1969 - 1976 Corvette: Service Bulletin: Air Conditioning Compressor Drive Belt to Radiator Hose Interference

Subject: Air Conditioning Compressor Drive Belt to Radiator Hose Interference

Bulletin Number: 76-T-21, Section VI - (May 1976)

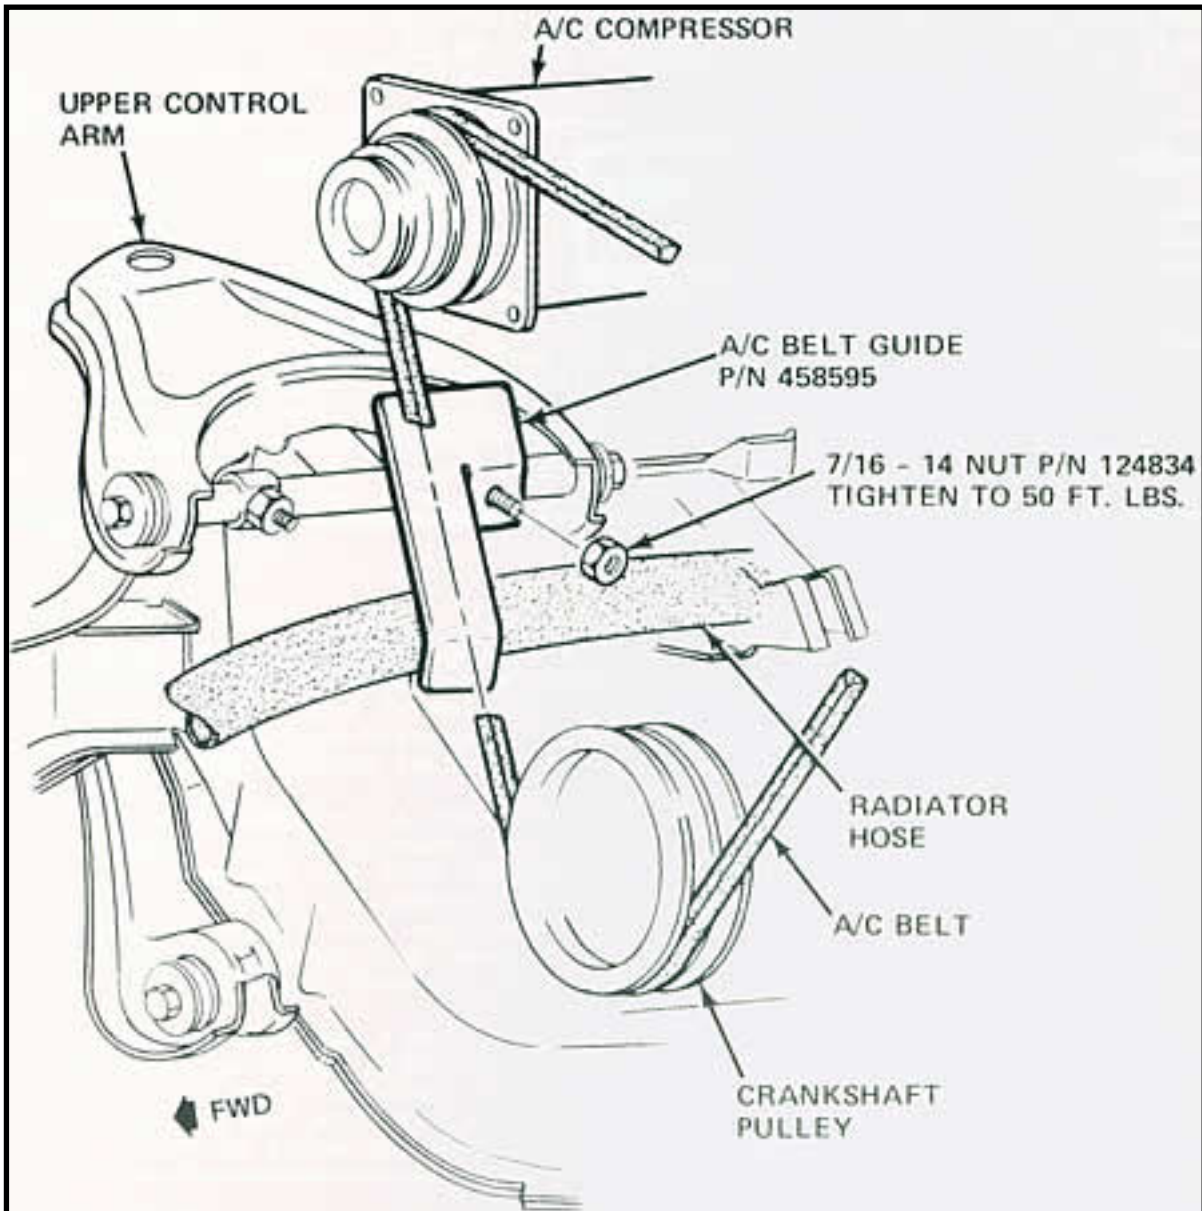
Some 1976 and past model Corvettes equipped with the 350 cubic inch engine and air conditioning may experience an interference condition between the radiator outlet (lower) hose and the air conditioning compressor drive belt. This belt chafing condition could damage the hose and may cause eventual coolant loss.

Belt to host interference has been eliminated by installing a belt guide, part number 458595, at the assembly plant. This guide is mounted over the rear attaching bolt for the upper right side control arm. The guide is between the belt and hose and prevents the belt from chafing the hose (see illustration on the following page). The belt guide went into production on vehicle identification number 6S416060 December 18, 1975.

This condition can be corrected on past model and vehicles built prior to the VIN cutoff by installing the belt guide as shown on the illustration. The belt guide can be obtained from GMPD. Use nut, part number 124834, to attach guide over the top of the existing rear upper control arm nut and torque to 50 ft.-lbs.
